Project: Clonburris T2, Dublin – Daylight, Sunlight & Overshadowing (DSOR) – Further information Response SDZ 22A/0018

I hereby write to you with regards to the design changes made to the development and in addition to this in response to the request for further information with regards to the following project, Clonburris T2.

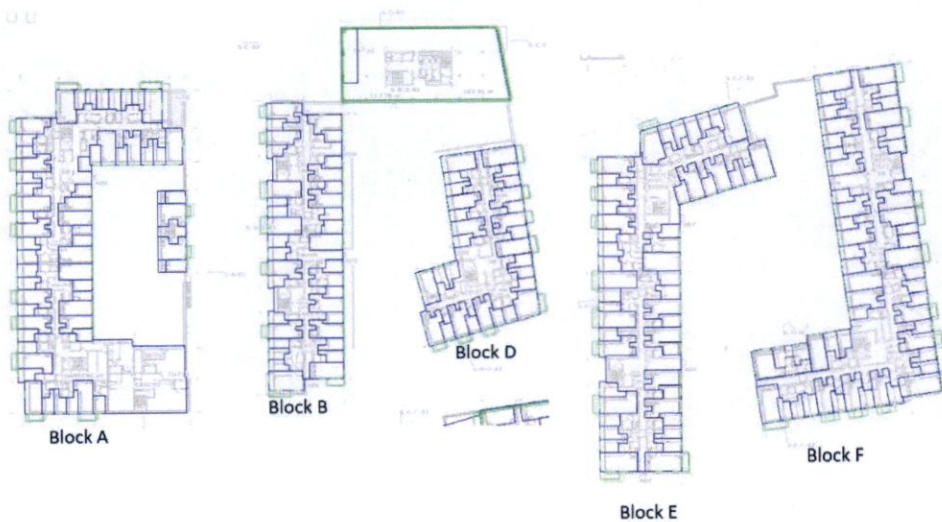
With reference to item 6(b) the landmark building and design alterations to the scheme, there are no additional impacts. Furthermore, when compared to our model the design changes show a decrease to the depth of all the spaces (refer to the screenshot below). This design change will only improve the daylight within all these spaces as the light will be able to project deeper into the space as a result of this reduced depth. Subsequently the overall performance of the development will only improve on what has already been submitted. Therefore, no additional assessment needs to be completed in our opinion.

Item no. 7(b) Daylight to Existing Buildings

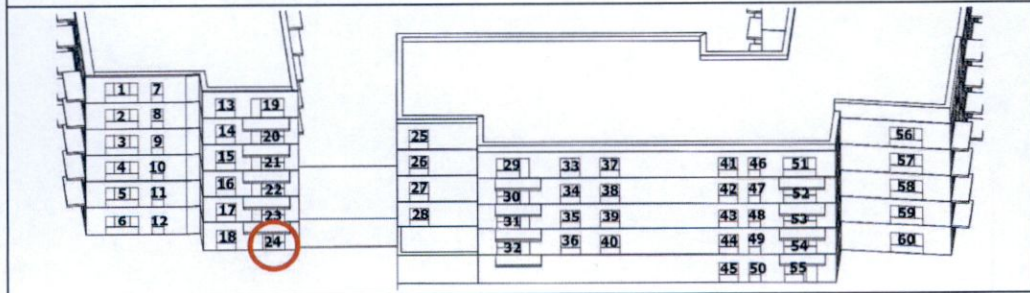
- Daylight existing buildings – neighbouring dwellings of Phase 1A and 3 assessed. 97% have a proposed VSC not less than 0.8 times their former value. 3 points drop below this value. The justification provided states 2 are dual aspect apartments and have large windows and have windows on a secondary elevation. Also, Phase 1A was tested with a future massing for Phase 2 in place. The applicant is requested to set out the details of the third property that falls below the standard. **Additional information.**

In response to this further information request, as per Section 2.1.6 of the BRE Guide, if the VSC value in the proposed scheme is less than 0.8 times its value (that of the existing) however it is between 15% and 27%, adequate daylight should still be expected if larger than conventional windows are being adopted. Window no.24 has a Proposed VSC value of 20.29 and has larger than conventional windows (total glazed panels of 2.8m by width and 2.25m by height), therefore adequate daylight would be expected within this space. It is further noted that the unit is dual aspect.
